**HISTORIC PRESERVATION REVIEW BOARD  
STAFF REPORT AND RECOMMENDATION**

Landmark/District:	<b>Greater U Street</b>	<input checked="" type="checkbox"/> Agenda
Address:	<b>725 T Street NW</b>	<input type="checkbox"/> Consent
		<input type="checkbox"/> Concept
Meeting Date:	<b>May 4<sup>th</sup>, 2017</b>	<input checked="" type="checkbox"/> Alteration
Case Number:	<b>17- 305</b>	<input type="checkbox"/> New Construction
Staff Reviewer:	<b>Imania Price</b>	<input type="checkbox"/> Demolition
		<input type="checkbox"/> Subdivision

Owners 725-727 T Street LLC request permit review for construction of a new steel framed canopy over an existing sidewalk café to 725 T Street, NW in the U Street Historic District.

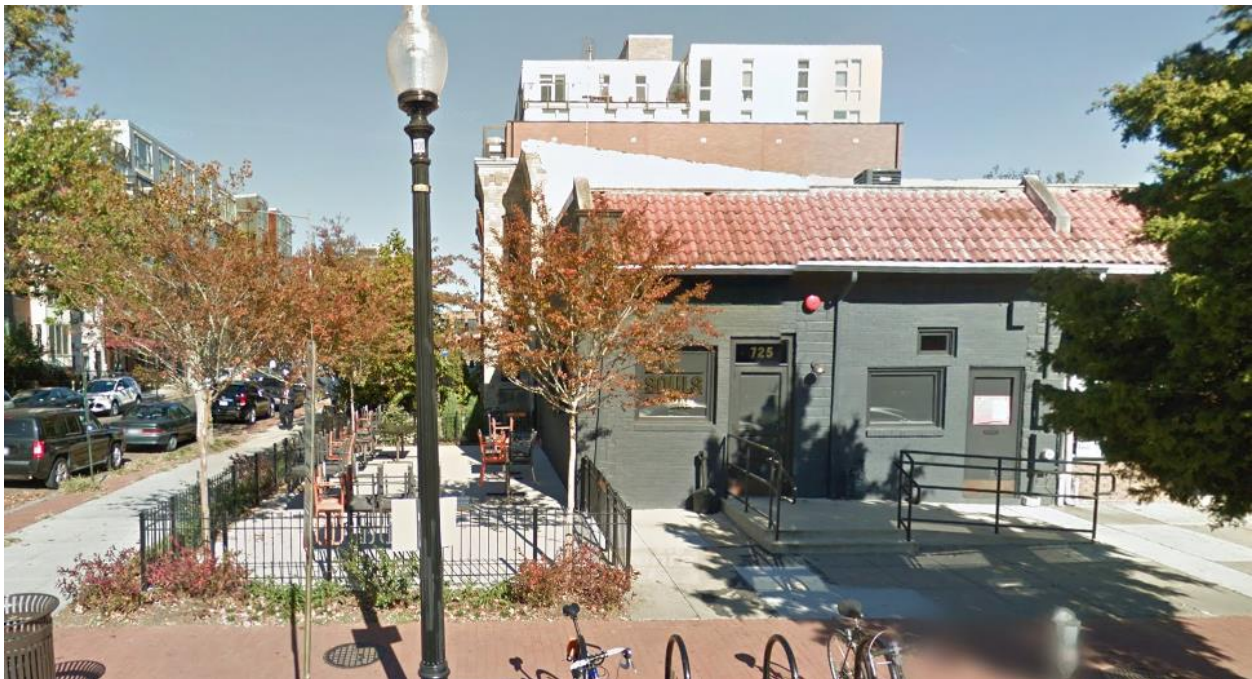
While a canopy over a sidewalk café may be appropriate, the type of the canopy depends on the specific characteristics of the historic district and building type.<sup>1</sup> In this instance, the size, visual weight, and extent of projection of the canopy structure is disproportionate to the modest building, dominating the public space of this primarily residential sidewalk along 8<sup>th</sup> street. Given the surrounding context is primarily mixed use with residential along 8<sup>th</sup> street and commercial along T St, the proposed canopy will detract from the character of the row by obstructing views of the building elevations and adds excess clutter to an otherwise green public space. Constructing the canopy without a setback from the storefront façade diminishes the character defining features of the storefront and highlights the bulky canopy structure along the building.

The DC public space regulations state that fixtures in a sidewalk café should not be a permanent structure.<sup>2</sup> Those regulations go on to state that “the attachment of a canopy through masonry is prohibited unless justified by the specific characteristic of the building” to which the applicant has not defended as necessary.

While sidewalk cafés are prevalent in the historic district, they typically employ umbrellas, retractable awnings, or fabric canopies on light-weight frames as a way to provide weather and sun protection for sidewalk cafes. The Board’s *Design Guidelines for Historic Commercial Buildings* states that “awnings and canopies should be made of treated, weather-durable fabric such as canvas or woven acrylic. Vinyl, metal, and plastic are not appropriate awning or canopy materials.”

The proposed canopy is not compatible with the character of the historic district, nor consistent with the Board’s guidelines or the city’s public space regulations in its size, material, or its relationship to the building to which it is being attached.

*The HPO recommends that the Board find issuance of the permit as inconsistent with the purposes of the preservation act and incompatible with the character of the historic district.*
